# **PRODUCT ADVISORY**

## **Data Sheet Specification Correction for the Listed Intersil ISL4270\* QFN Packaged Products**

**Refer to:  
PA10061**

Products Affected: **ISL4270EIRZ ISL4270EIRZ-T**

## Incorrect POD – PA10061

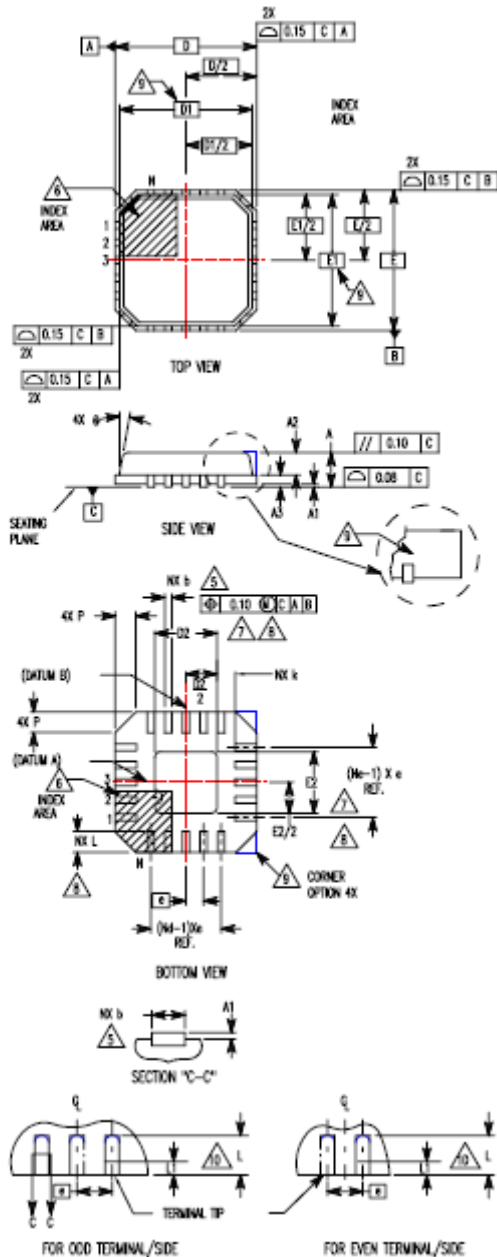
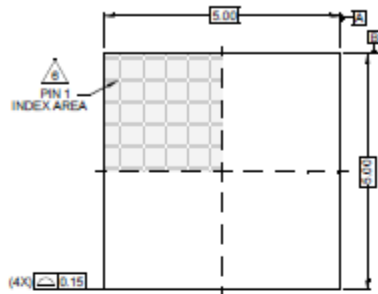
This advisory is to inform you that Intersil has made corrections to the POD (Package Outline Drawing) referenced in the data sheet specification for the listed Intersil ISL4270\* QFN (Quad Flat No-Lead) packaged products. The updates to the POD correct the exposed pad dimensions and incorporate Intersil's new POD format. There have been no changes made to the package or product itself. The updated data sheet incorporating the corrected POD is available on the Intersil web site at <http://www.intersil.com/data/fn/fn6041.pdf>.
